TECHNICAL QUERY
Hollandse Kust Noord

No. TQ :	CW-ROS-TQ-0001	Rev:	A

Originating Party	CrossWind					
Subject	Separation between 40ft BESS Containers					
Author	Stephen Bremner	TQ Aconex unique number: CWHKN-INN-BPH-TQ-00005				
Interface TQ - from	n.a.	TQ interface source Aconex unique number: n.a.				
Type	Query		X	Interface		
	Deviation			Derogation (SHALL[PS])		
	Note: No deviations nor derogations which have an adverse effect on HSSE will be granted					
Workpackage	BLPH					
Area(s) of application	Design & Eng.	X	Procurement		Construction	
	Commissioning		Operations		Other	
Issue date	04/08/2023		Urgent reply 5 days		Routine reply 10 days	X
Close-out date	06.09.2023					
Closed-out by	TB		TQ status:		Closed-out

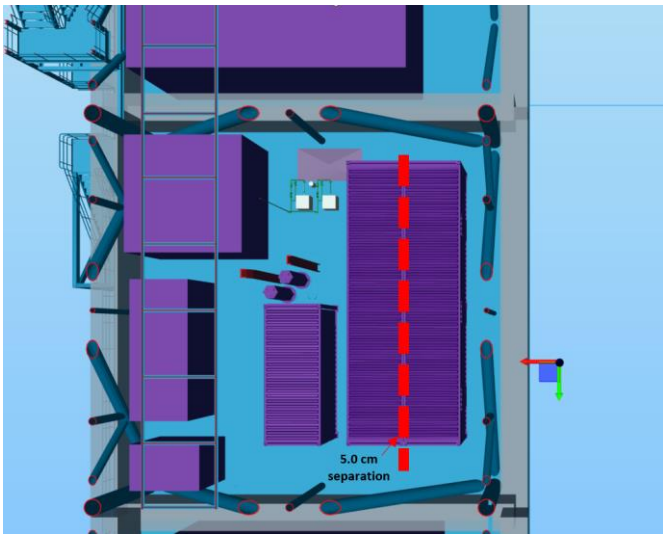
COMPANY would like to request CONTRACTOR to accommodate a 5.0 cm separation between the 40ft BESS Containers in the design of the BLPH Topsides. These BESS containers are placed on the Lower Deck. The location of the 5.0 cm separation is illustrated below in red:

CONTRACTOR to confirm that this can be accommodated and included in the design.

2. Response
Reference documents / Aconex unique numbers
CONTRACTOR confirms request can be accommodated and included in the design.
